ADDENDUM NO. 1

Date: March 23, 2004
To: Interested Parties
From: Bill Bowen, DFCM Program Director
Reference: Weber State University
Engineering Technology Building Remodel
DFCM Project #02148810

**Addendum No. One
for the
Weber State University Engineering Technology Building Remodel
Remodel Bid Documents
DFCM Project No. 02148810
WSU Project No. ET-01006
MHTN Project No. 2003604**

MECHANICAL ADDENDUM NO. 1

Original Sheet No:
PL101

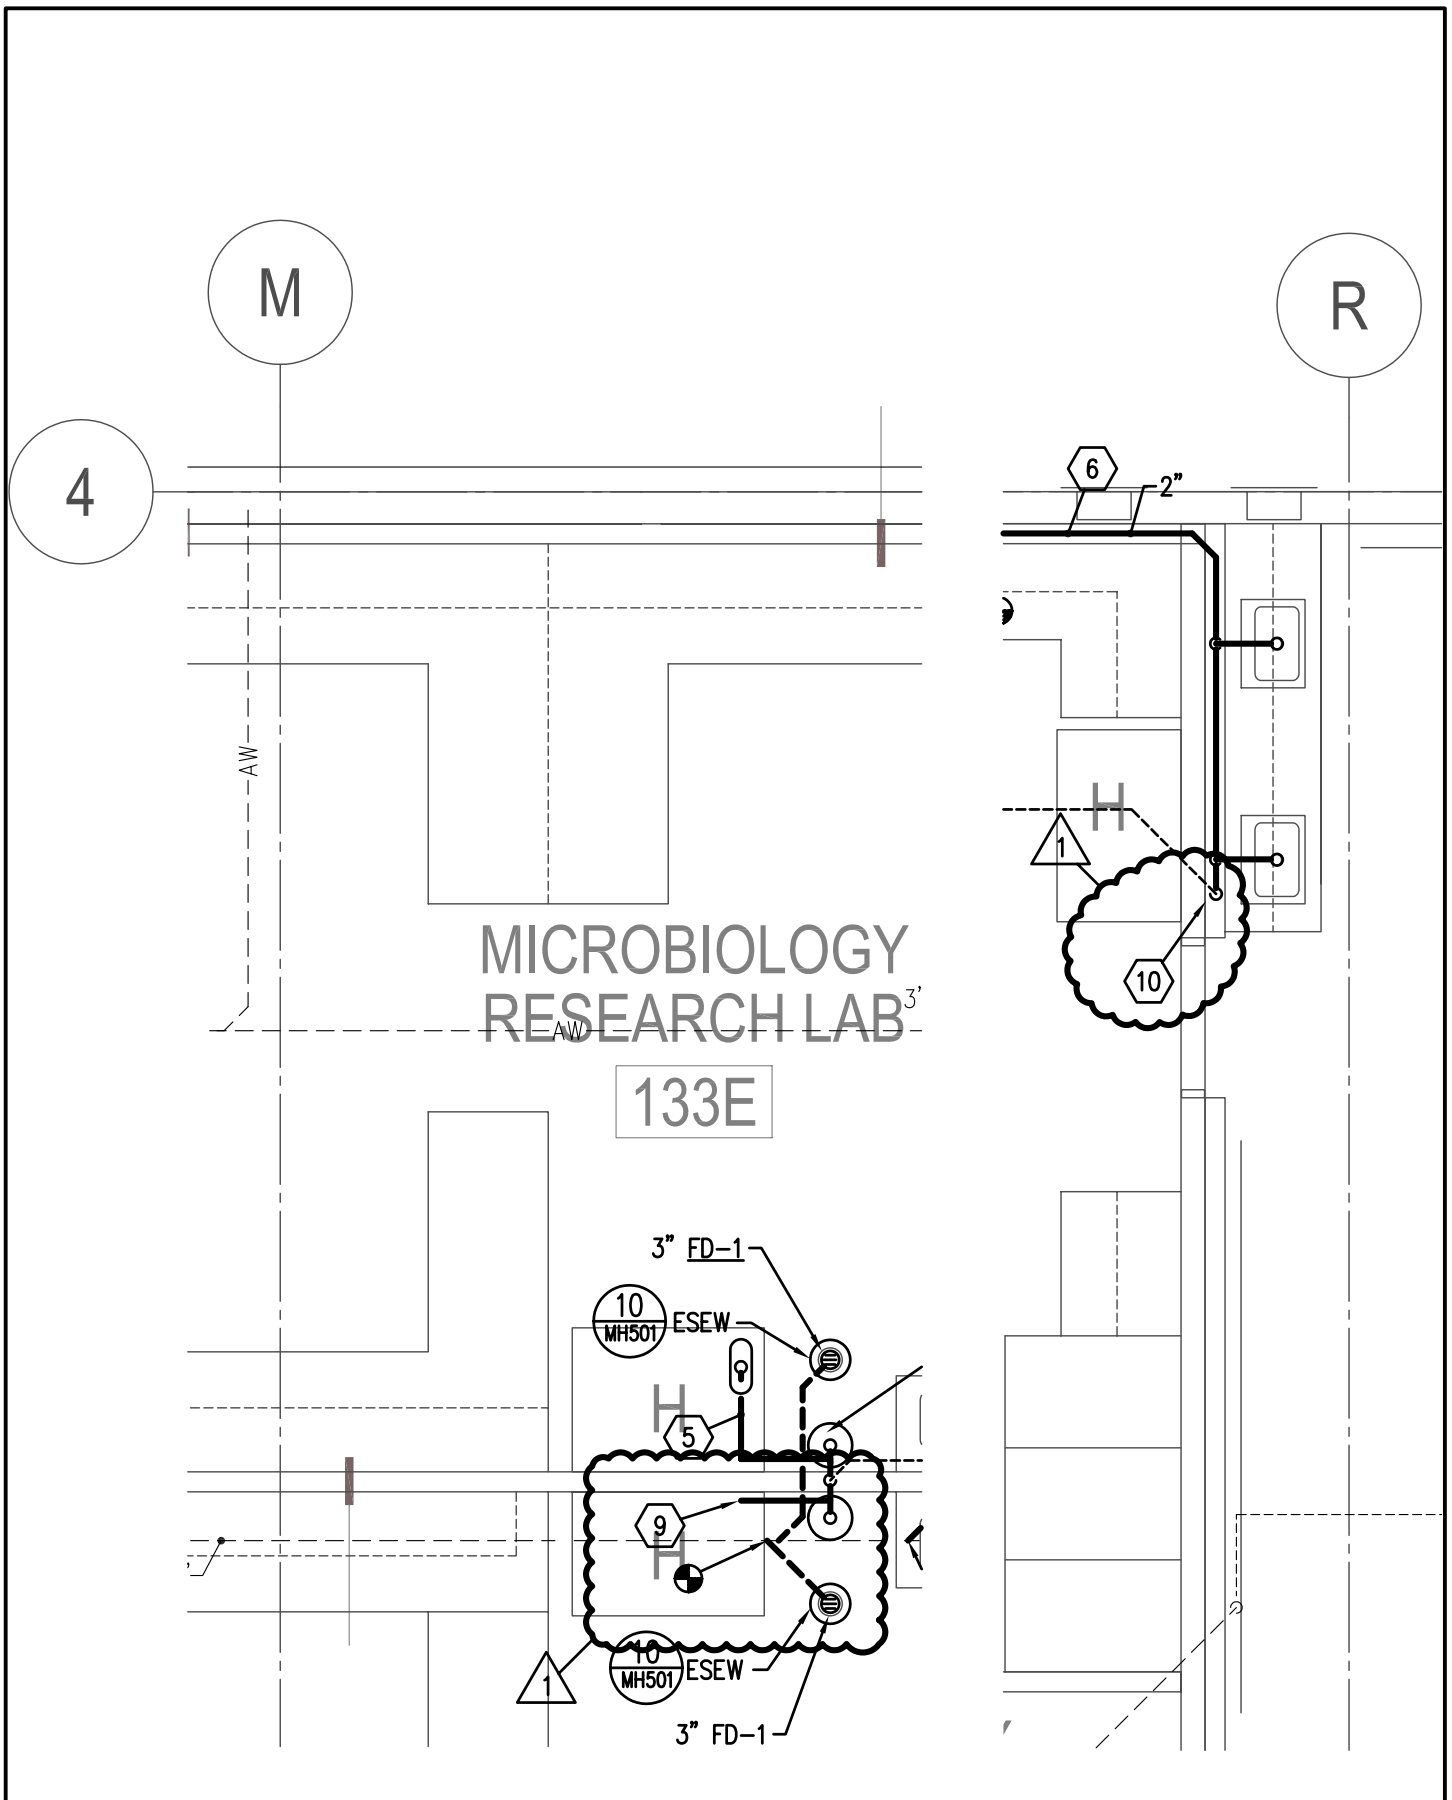
Item No.	Add, Delete or Clarify	Drawing No.	Reference / Description:
1	Clarify	PL101	ADD 1.01, ADD 1.02: Add keyed notes 9 and 10 instructing contractor to provide connections to future cup sinks Clarify General Note A and add General Note E
2	Clarify	PL102	ADD 1.03: Show location of and cold water hookups to trap primers Change detail call out 11/MH501 to 10/MH501
3	Clarify	PL102	ADD 1.04: Add keyed Note 2 to indicate trap primer location Modify keyed note 7 to clarify that hookups need to be provided to present and future hoods
4	Clarify	PL401	ADD 1.05: Clarify pipe sizes to emergency showers and eyewashes
5	Clarify	MH101	ADD 1.06 Change keyed note 4 to keyed note 1 at acid vent and indicate flow from cabinet Show location of thermostat for air handler
6	Add	MH101	ADD 1.07, Show locations of thermostats for alternate 1
7	Clarify	MH401	ADD 1.08: Indicate that vent from PT-1 shall be routed to outdoors

STEAM PIPING DIAGRAM

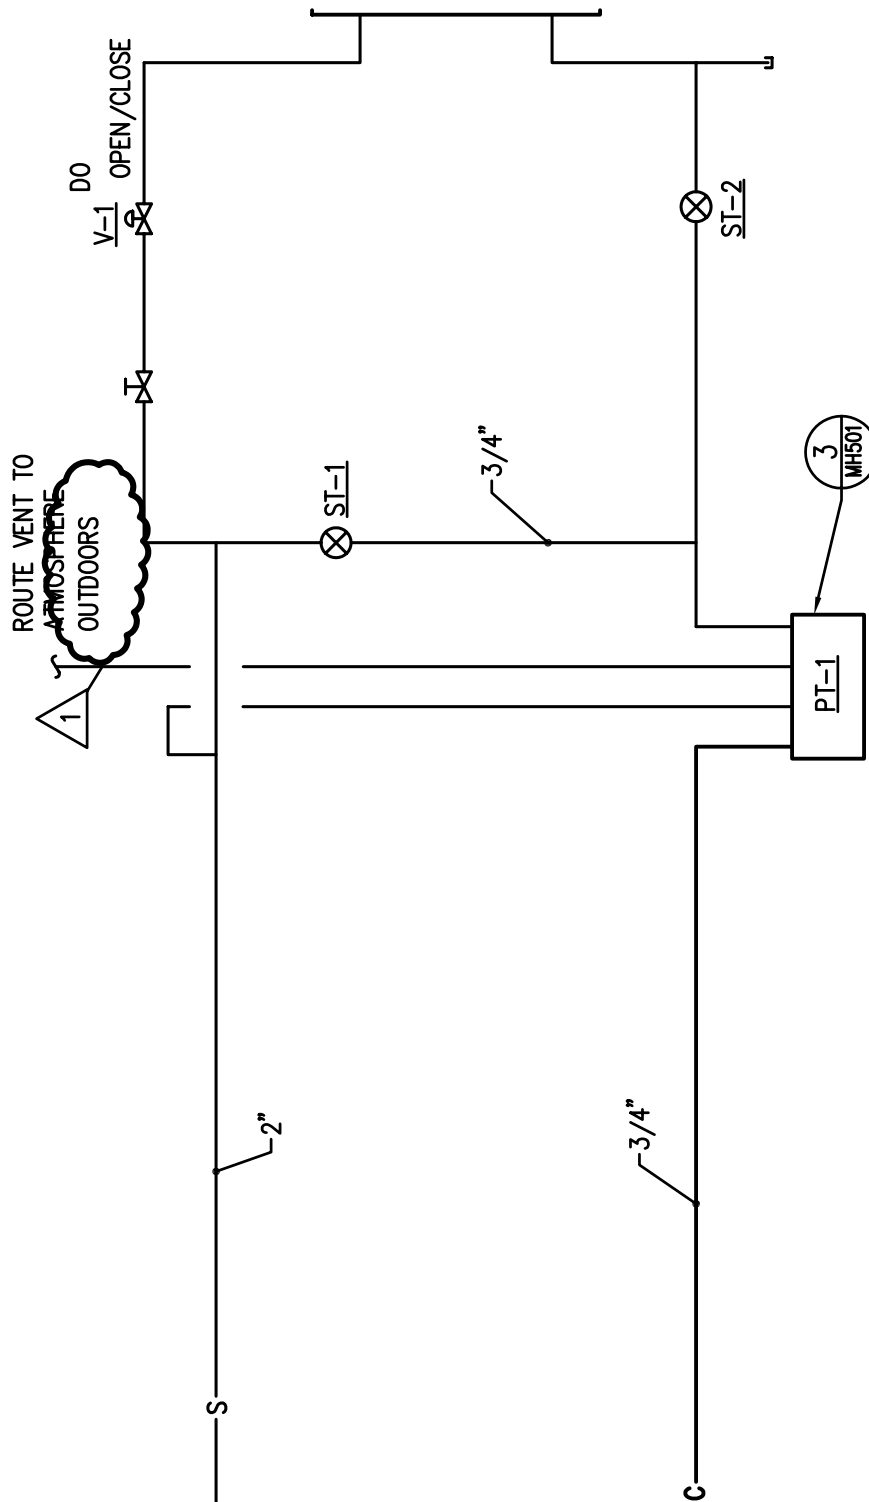
- 2 TRAP PRIMER LOCATION
- 7 DROP HOOD SERVICES IN CHASE CREATED BETWEEN STUDS. PROVIDE BALL ISOLATION VALVES FOR IW AND CA. COORDINATE VALVE LOCATION WITH ACCESS PANEL SHOWN ON ARCHITECTURAL ELEVATIONS. PROVIDE HOOKUPS TO NEW HOODS OR STUB-OUTS FOR FUTURE CONNECTIONS.

ADD
1.09

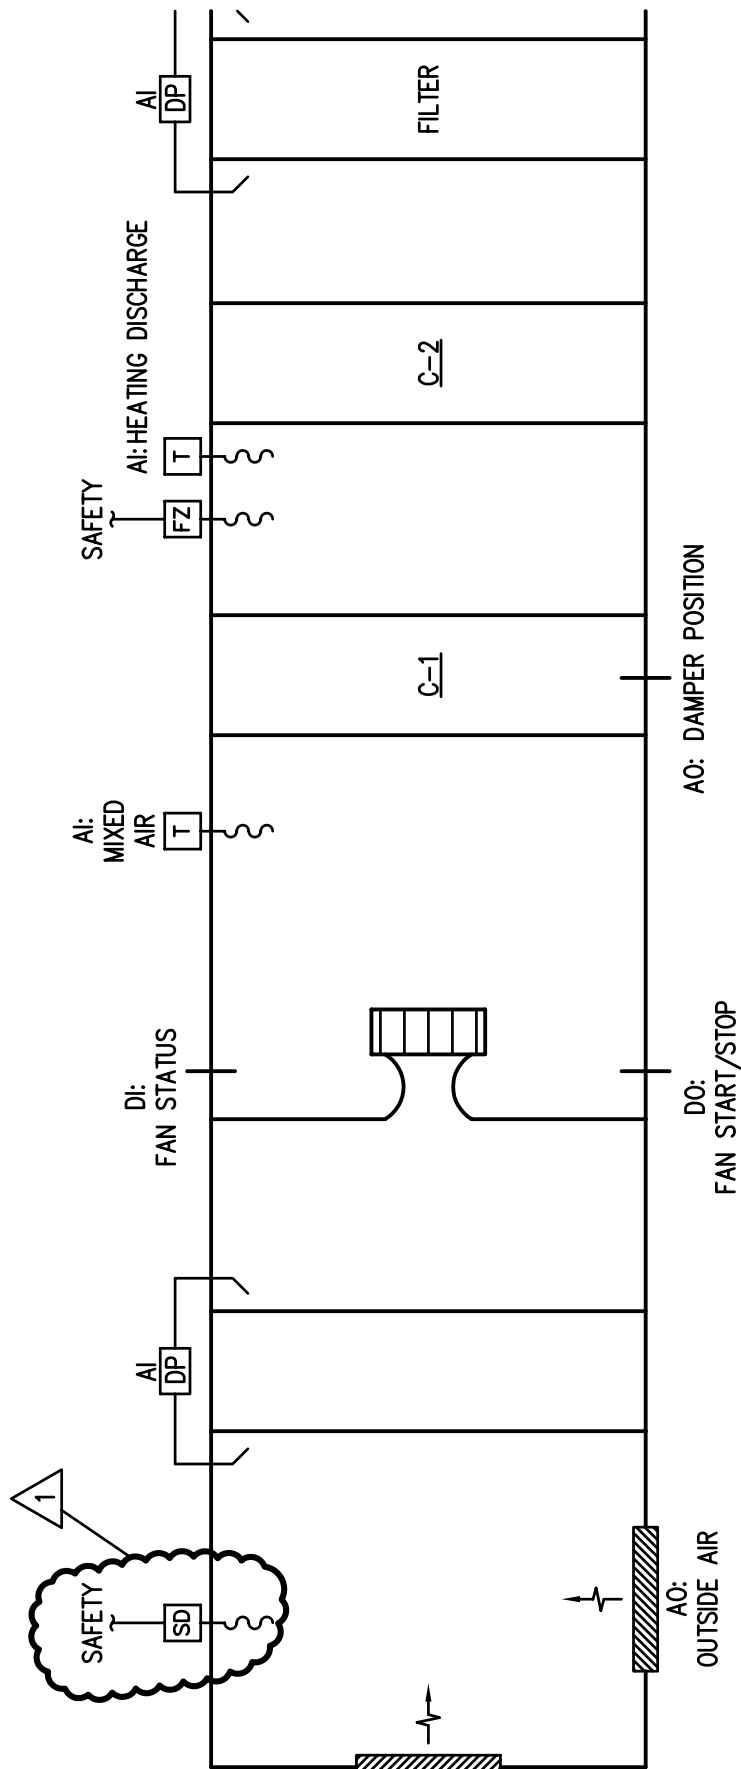
8	Clarify	MH401	ADD 1.09: Delete redundant two-way valve V-2, and add control point to existing three way valve
9	Change	MH401	ADD 1.10: Move smoke detector to air handler return
10	Change	MH501, Detail 6	ADD 1.11: Clarify detail

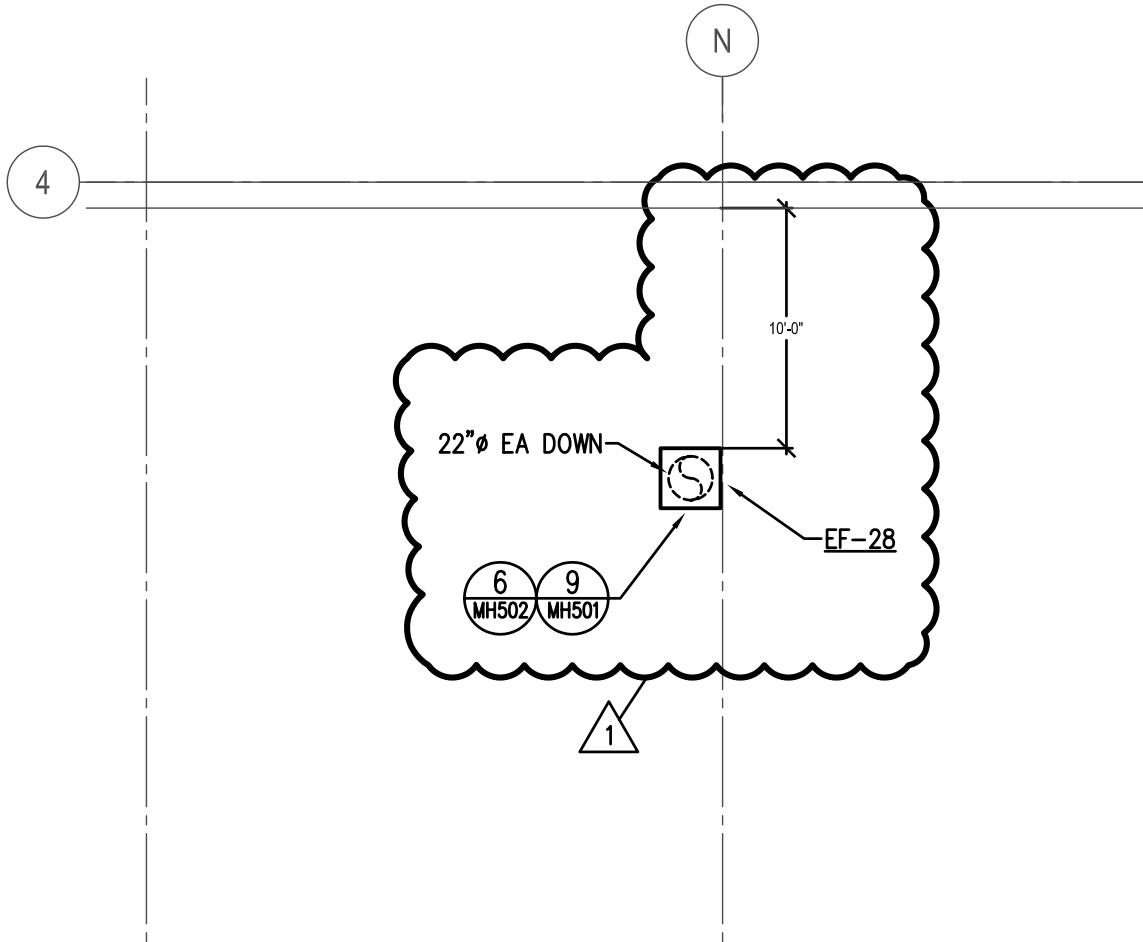
Item No.	Add, Delete or Clarify	Drawing No.	Reference / Description:
11	Clarify	MH501, Detail 8	Note that 10'-0" dimension above roof is minimum height of discharge
12	Clarify	MH501, Detail 8	Provide support as required for fan stability (i.e. guy wire, manufacturer's recommendations)
13	Change	MH501, Detail 10	ADD 1.12: Change connection size to shower, show cold water connection to trap primer
14	Change	MH601	ADD 1.13: Change exhaust fan motor size from 2 hp to 3 hp
15	Add	MH502, Detail	ADD 1.14: Add exhaust duct offset detail
16	Change	MH101	ADD 1.15: Move EF-28 to the west
